Accessibility Plan

**KIRKLEES COUNCIL
PHYSICAL RESOURCES & PROCUREMENT****GROUND FLOOR ACCESSIBILITY REPORT**

PROJECT NO: AM490899
PROJECT: WESTBOROUGH HIGH SCHOOL
DATE: 10 JANUARY 2014

To be read in conjunction with drawing **001/01** this indicates the following:

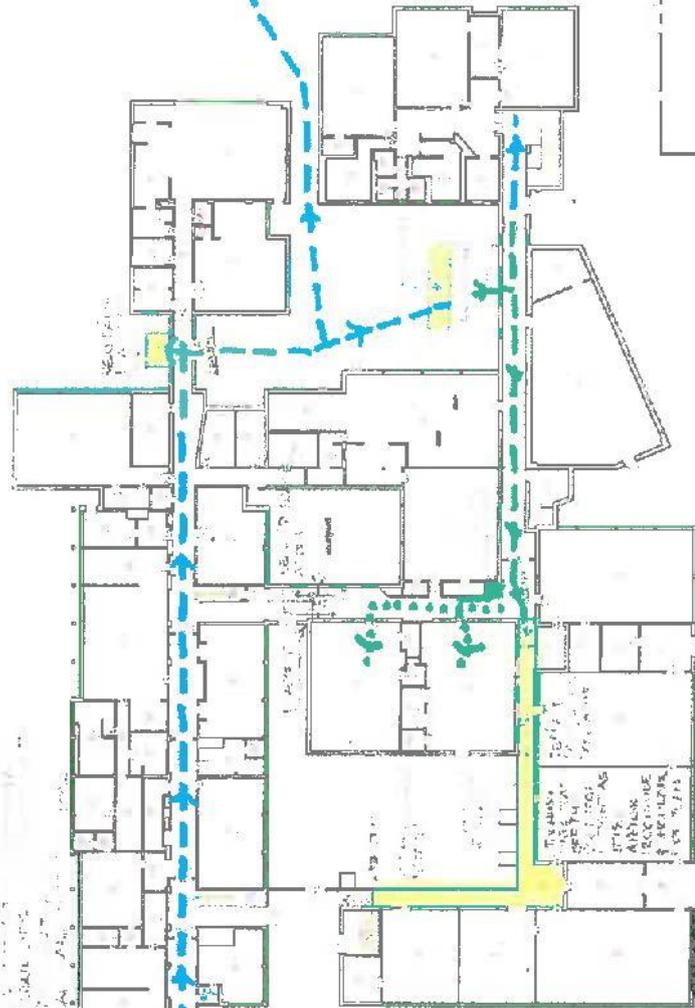
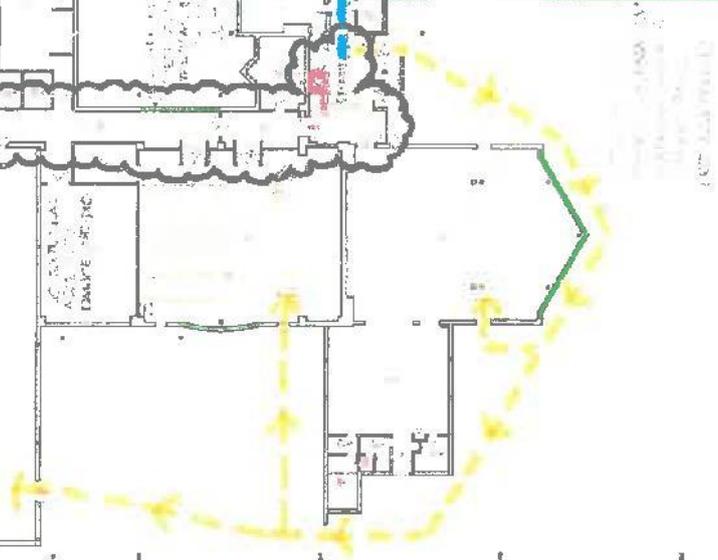
However, these are not possible without major changes to the existing building. In many cases ramps and associated landings (at 1:12 not ideal, 1:15 or 1:20 is preferred) cannot be accommodated as the lengths required will not fit within the area available, achieving this will require ramps that are too steep for their use.

It will be necessary to consult with both Building Control and Fire Safety as stair lifts if introduced will reduce the width of the stairs and also the width of the escape routes, particularly if the lifts are being used during class change, lunch or an emergency evacuation procedure.

- External routes to dining hall, main hall, gymnasium (orange)
- Location of stair lift (green)
- Location of vertical lift (pink)
- Location of additional ramps and lifted floor levels (yellow)
- Areas where insufficient spaces are found for ramps and landings and where access and escape routes would be reduced (black cloud)
